Screen shots of 24V,2A schematic and PCB board layout:

Screen shots of 24V, 2A PCB board layout:

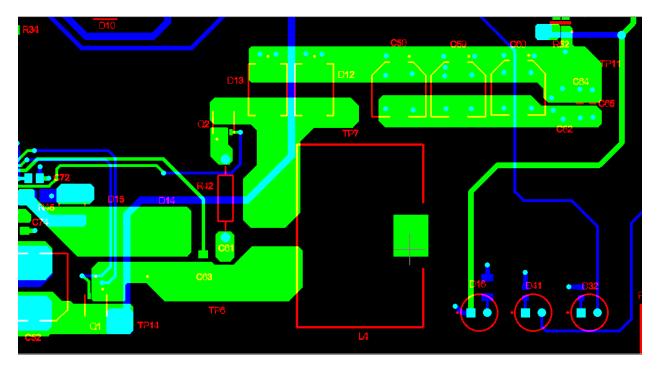
In above layer D15, D14 footprint is wrong, but we have corrected in component assembly for testing.
